MILITARY SPECIFICATION

CASE, SHIPPING, MULTIPURPOSE: 10539225

This amendment forms a part of Military Specification MIL-C-60182(MU) dated 1 March 1965.

FIGURE 6 - CUSHION INSERT

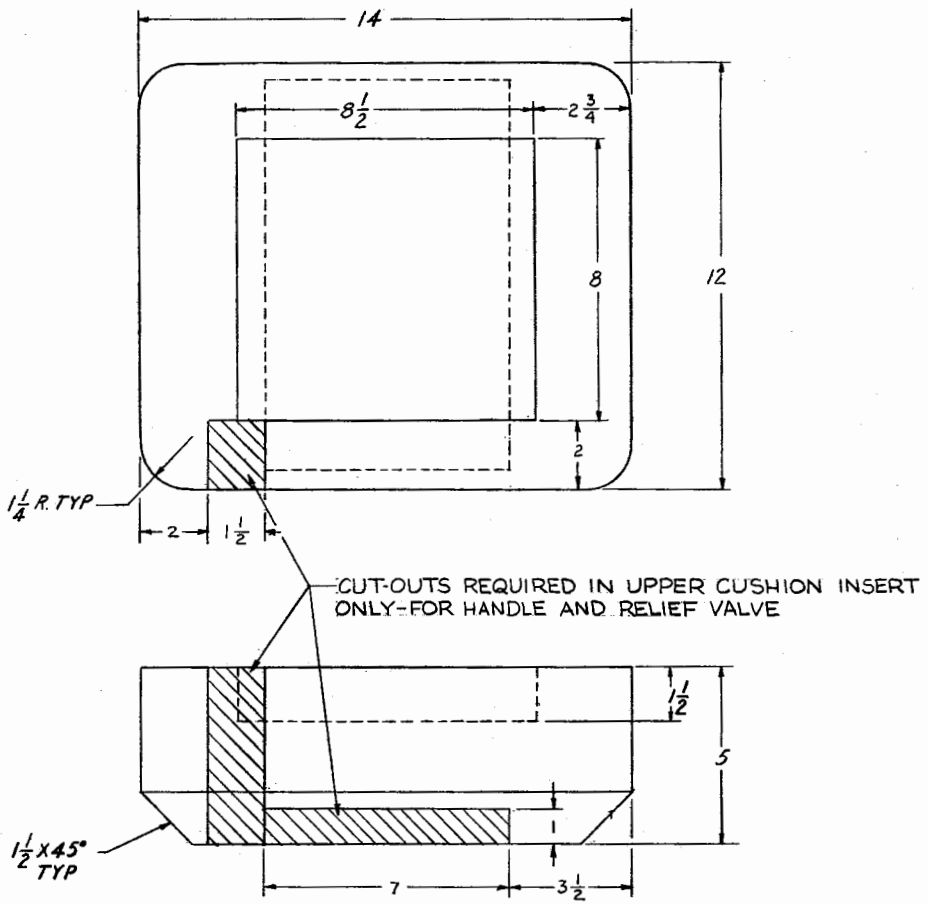
* Delete: "Figure 6" and substitute attached "Figure 6".

1. INTERCHANGEABLE CUSHION INSERTS SHALL BE FABRICATED BY DIE CUT METHOD FROM POLYURETHANE (POLYETHER FORMULATION) 1.8 LBS/CUBIC FOOT DENSITY CONFORMING TO MIL-P-26514. COLOR-CHARCOAL OR GRAY.
